Access Compliance Report

Public Rights-of-Way

Intersection ID: 5638	Main Street: BELLHAVEN_BV	Cross Street: KENTBERRY_DR	Location: S
ADA ID: 9B916C8794B3	Ramp Type: BlendTrans1	Initial Pass/Fail: Pass	Overall Compliance: No
		Severity Score: 2.5

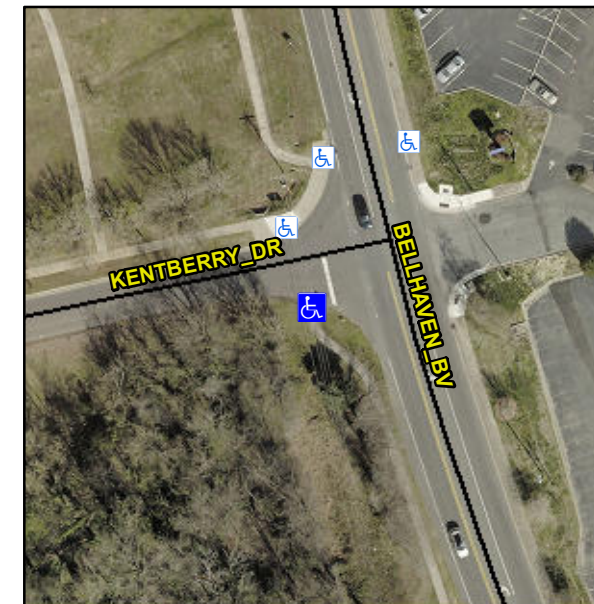
Surveyor Notes:

NO CURB

PROW/ADA:

R304.2.1, R305.1.4, R305.2

Possible Solutions:

Remove & Replace Curb Ramp With Two New Directional Ramps or Equivalent.
